# Access Compliance Report

## Public Rights-of-Way

### (Curb Ramps)

Intersection ID: 51507	Main Street: ALDERSON_DR	Cross Street: NETHERTON_LN	Location:	N
ADA ID: D2DAA78882D1	Ramp Type: BlendTrans1	Initial Pass/Fail: Fail	Overall Compliance: No	Severity Score: 10
Codes/Mitigation Info/Possible Solution		Field Measurements/Component Compliance

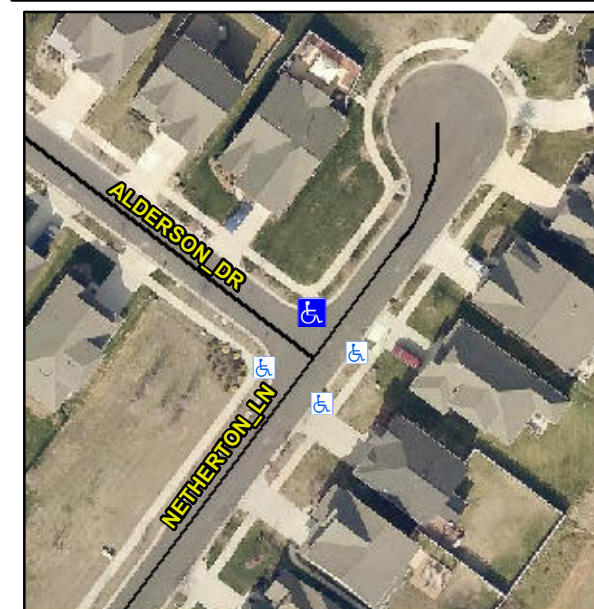
**Not Found, R304.5.1, R304.5.3**

Compliance	Description	Data	Compliance	Description	Data
N/A	Ramp Length (in)	71.5	Yes	BlendTrans Slope (%)	4.9
No	Ramp Width (in)	42.0	No	BlendTrans XSlope (%)	3.8
N/A	Flare Type LT	N/A	N/A	Flare Type RT	N/A
N/A	Flare Slope LT (%)	N/A	N/A	Flare Slope RT (%)	N/A
N/A	Flare Traversable LT?	N/A	N/A	Flare Traversable RT?	N/A
N/A	Landing Length (in)	N/A	N/A	DWS Provided?	N/A
N/A	Landing Width (in)	N/A	N/A	DWS Contrast?	N/A
N/A	Landing Slope (%)	N/A	N/A	DWS Length (in)	N/A
N/A	Landing X Slope (%)	N/A	N/A	DWS Full Width?	N/A
N/A	Landing Curb? (Y/N)	N/A	N/A	DWS Offset (in)	N/A
N/A	Shared Landing?	N/A			
N/A	Gutter Ponding?	N/A	N/A	Gutter Slope (%)	N/A
N/A	Gutter Lip Ht (in)	N/A	N/A	Gutter X Slope (%)	N/A
N/A	Painted X Walk1?	No	N/A	Painted X Walk2?	No
	X Walk 1 Direction	To SW		X Walk 2 Direction	To SE
	X Walk 1 Width (in)	N/A		X Walk 2 Width (in)	N/A
	X Walk 1 Slope (%)	3.6		X Walk 2 Slope (%)	2.8
	X Walk 1 X Slope (%)	2.1		X Walk 2 X Slope (%)	4.4

N/A	Ramp inside XWalk1?	N/A	N/A	Ramp inside XWalk2?	N/A
	Road Slope (%)	1.3		Clear Space?	N/A
	Road X Slope (%)	4.7	N/A	Clear Space to XWalk (in)	N/A
N/A	Any Obstructions?	N/A	N/A	Storm Grate/Utility Hazard?	N/A
	Obstruction Type			Storm Grate/Utility Type	
		N/A			N/A
			Yes	Surface Condition? (G/P)	Good
			No	Curb Slope (%)	19.1

**Remove & Replace Curb Ramp With Two New Directional Ramps or Equivalent.**
